PLANNING COMMISSION AGENDA

Approval of Comprehensive Plan Amendment, Zoning Map Amendment, Preliminary Plat, and Final Plat of Diamond Creek Addition

Engineering Comments (with applicant's response), Sep 23, 2024

| To: | Jon Sevald, Planning | From: | Jason Quisberg, Stantec Nick Findley, Stantec Josh Accola, Stantec |

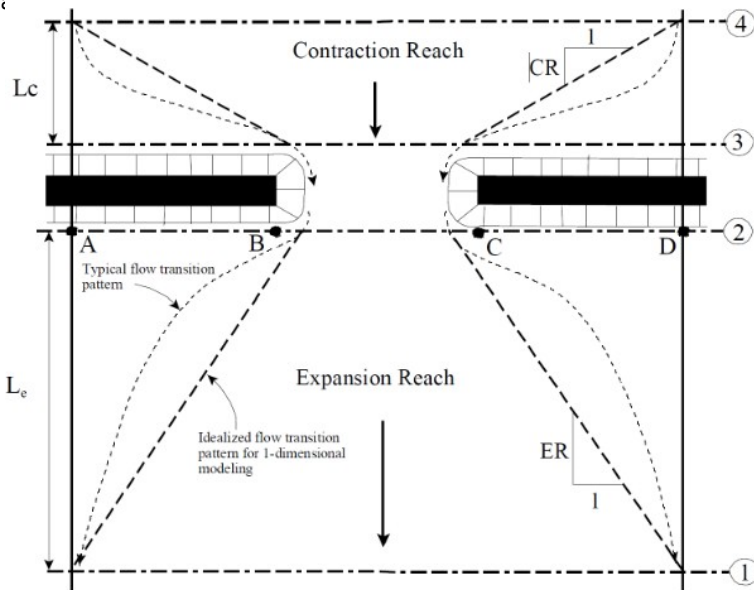
78. Add ineffective flow areas upstream, downstream, and at bridges (9.5, 13.5) using RAS four (4) XS approach.

- Resolved - The City's engineers stated that as long as the project remains out of the floodway and compensatory storage is provided within the flood fringe, there is no additional modeling that would be required. As addressed in comment response 62, the project remains out of the floodway and compensatory storage has been provided.

SOUTH E-W ROAD

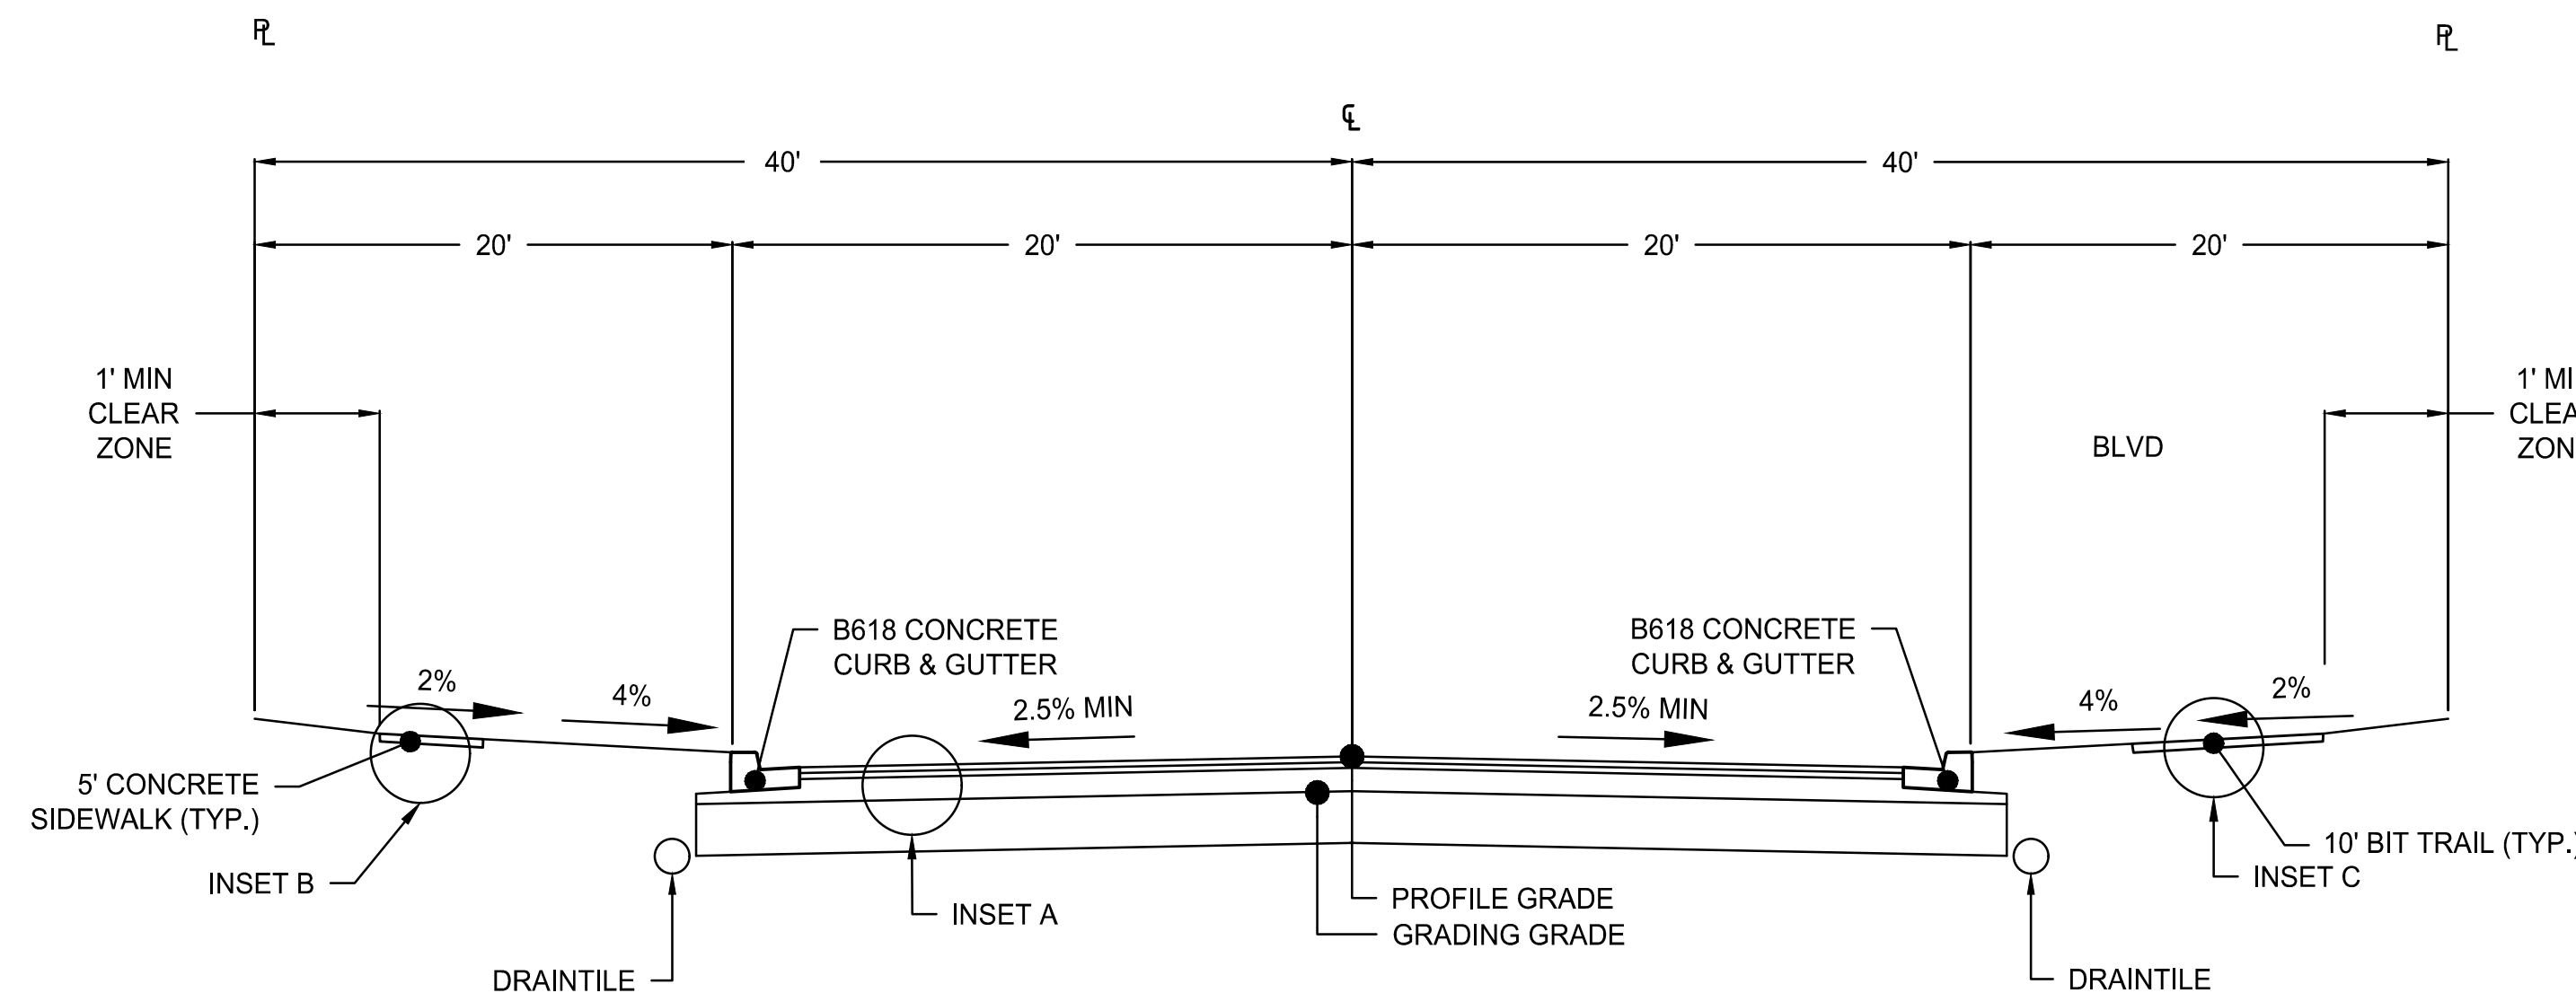
- o No action needed.
13. Recommendation from engineering is an 80' right of way with 40' roadway for the east west road. After council discussed with applicant (9/12/2023 council meeting), council suggested a 60' right of way could be considered for the east west road. Currently the roadway is proposed as 50' right of way in the plat documents and 46' in the typical section. Revise ROW to be 60' with a 36' wide roadway (face to face) to provide for two

- o City code states that a minor or marginal street is a street primarily used for access to abutting properties. The south private street (east-west road) will be used for access to future abutting properties (commercial developments in Outlot F). The street will not provide access or connections to any other roads, and by definition meets the minor or marginal street classification. The right-of-way width required for a minor or marginal is 50 feet per city code. The only classification types that would potentially require a 60' right-of-way width are local streets or neighborhood collectors. By definition, both local streets and neighborhood collector streets connect neighborhoods and provide access to local and collector streets (neighborhood collectors also provide access to minor arterials). The south private street does not fit the definition of a local or neighborhood collector road and would therefore not require the requested 60' right-of-way.
